RE: 83rd Joint Venture; ID # M-1992-069

Re: Response to Comments Provided by the Division of Reclamation, Mining and Safety and Aggregate Industries Regarding the 83rd Joint Venture Pit

This letter, prepared by Wright Water Engineers, Inc. (WWE) on behalf of the Boyd Irrigation Company (BIC), addresses the BIC's flood damaged pipeline for the Boyd-Freeman Ditch. The damaged pipeline section is located north of F Street and west of the 83rd Joint Venture gravel pit owned by Aggregate Industries.

Photo B.1 - View south along embankment of AI pit with water beginning to flow over the embankment.

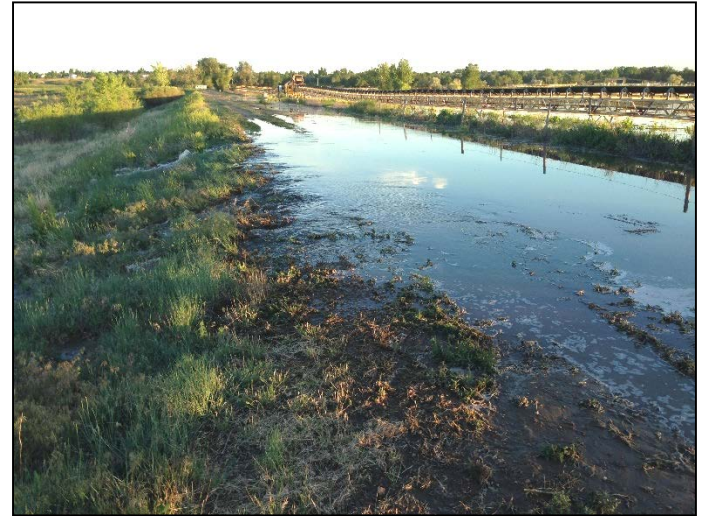
- Photos taken by Roger Schmidt, BIC President, on May 27, 2014 during the early stages of the 2014 flood event, show a broad sheet of flow reaching the top of the pit's embankment and starting to flow down into the pit (see photos in Appendix B to this letter). The photos do not show a distinct location with settlement in the pipeline that caused flows to concentrate down the embankment.

Sheet flow down the reclamation slope is the only mode of failure that is supported with evidence based on the information we have reviewed. Photos of water flowing over the crest of the embankment, taken during the early stages of the 2014 flood event, show evenly distributed sheet flow as it reaches the crest of the pit’s embankment.

**BOYD-FREEMAN DITCH AND F ST. PROPERTY
OVERVIEW MAP**

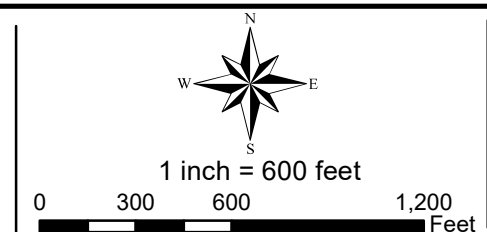
For clarification, the 2006 project referenced in the AI letter and in the attached correspondence is at the northeast end of the AI pit (see Figure in Appendix C). This location is separated by roughly 1,800 feet from the location where the ditch failure occurred in 2010 and where the pipeline breaches occurred in 2013 and 2014. In addition, the Boyd-Freemen Ditch was relocated by AI to its current alignment sometime between 1999 and 2001 (based on aerial imagery), which was several years before the referenced 2006 project took place.
